UNITED STATES PATENT AND TRADEMARK OFFICE

APPLICATION NO.	FILING DATE	FIRST NAMED INVENTOR	ATTORNEY DOCKET NO.	CONFIRMATION NO.
10/671,842	09/25/2003	Michael D. Brookshire	121236.00003	9648

Office Action Summary

DETAILED ACTION

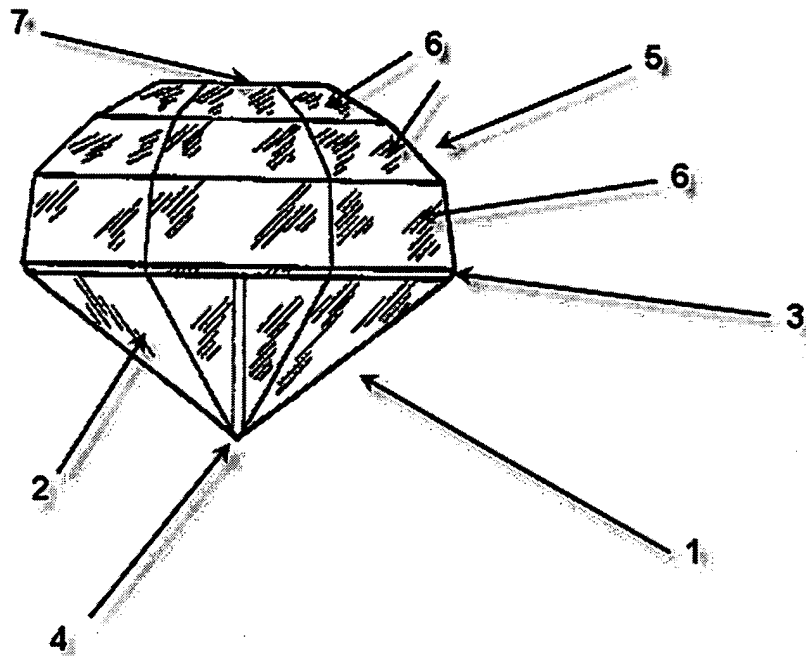
The shape and appearance of Stafford is identical in all material respects to that of the claimed design, *Hupp v. Siroflex of America Inc.*, 122 F.3d 1456, 43 USPQ2d 1887 (Fed. Cir. 1997).

As for Claim 1, Stafford teaches of a diamond (see figure below), comprising:

a pavilion (1) having a plurality of facets (2) disposed from a girdle (3) to a culet (4), each of plurality of facets (2) having a continuous flat surface extending from the girdle (3) to the culet (4), wherein an edge of a first adjoining facet (2) contacts an edge of a second adjoining facet (2) along a common radial boundary; and

a dome-shaped crown (5) disposed above the girdle (3), wherein the girdle (3) extends no further than a widest circumference of the dome-shaped crown (5) and the pavilion (1) extends no further than a widest circumference of the girdle (3), the dome-shaped crown (5) formed from a plurality of sets of facets (6) with an equal number of facets in each set, and the set of facets (6) cut with monotonically decreasing angles to form a stepped contour from the girdle (3) to an apex (7) of the dome-shaped crown (5), each of the sets of facets (2) having monotonically decreasing surface areas from the girdle (3) to the apex (7) of the dome-shaped crown (5).

Re: Claim 5, wherein the pavilion (1) is substantially conical in shape.

As for Claim 13, Stafford teaches of a diamond (see figure above), comprising:

a pavilion (1) extending from a girdle (3) to a culet (4), wherein the girdle (3) extends no further than a widest circumference of the crown (5) and the pavilion (1) extends no further than a widest circumference of the girdle (3); and

a crown (5) in the form of a symmetrical hemisphere having a first set of facets (first 6) disposed above the girdle (3) and a second set of facets (second 6) disposed between the first set (first 6) of facets and an apex (7) of the crown (5), wherein the first set of facets (first 6) is cut at a first angle with respect to a reference line which is tangential to the apex (7) of the crown (5) and the second set of facets (second 6) is cut at a second angle with respect to the reference line

which is less than the first angle, each of the sets of facets (first and second 6) having an equal number of facets (6).

Re: Claim 14, wherein each of the plurality of facets (2) of the pavilion (1) are symmetrically disposed and extend continuous from the girdle (3) to the culet (4).

Re: Claim 17, wherein the apex (7) of the crown (5) includes a star-shaped facet (as seen in Fig. 5).

As for Claim 23, Stafford teaches of a diamond (see figure above), comprising:
a pavilion (1) having a plurality of facets (2) disposed from a girdle (3) to a culet (4); and
a dome-shaped crown (5) disposed above the girdle (3), wherein the girdle (3) extends no further than a widest circumference of the dome-shaped crown (5) and the pavilion (1) extends no further than a widest circumference of the girdle (3), the dome-shaped crown (5) formed from a plurality of sets of facets (6) with an equal number of facets (6) in each set, the dome-shaped crown (5) has a stepped contour from the girdle (3) to an apex (7) of the dome-shaped crown (5).

Re: Claim 24, wherein each of the plurality of facets (2) of the pavilion (1) are symmetrically disposed and extend continuous from the girdle (3) to the culet (4).

Re: Claim 26, wherein the apex (7) of the crown (5) includes a star-shaped facet (as seen in Fig. 5).
